DOCUMENT 00202 - ADDENDUM NUMBER 1

Date: 24 June 2020

Proctor Recreation Center Roofing
309 S. Dusable Road
Peoria, Illinois 61605

DATE	PROJECT NO.
06.10.2020	2015904.23
DRAWN BY	SHEET
DAC	RF-2
CHECKED	APPROVED
DBV	SJM

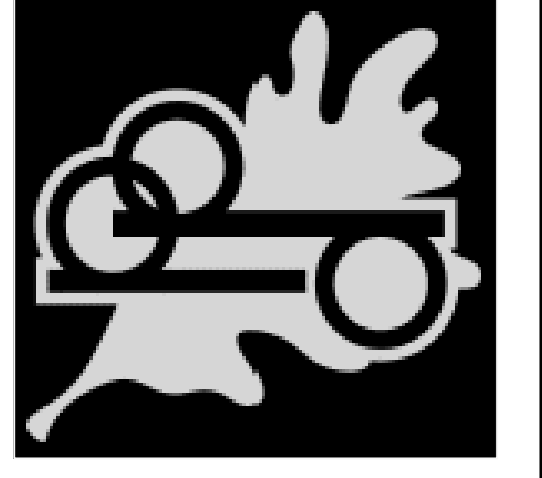
1. See the attached (1) RF-2 roof plan sheet with revisions to the tapered insulation layout shown in red. Tapered shall be 1/2"/FT. Replace the original document Rf-2 drawing sheet in its entirety with the one attached within.
2. Reference Drawing Sheet RF-3. Change this detail 4/RF-3 to a 2 piece counter-flashing. Removable type for future repairs of flashings or additional coatings.
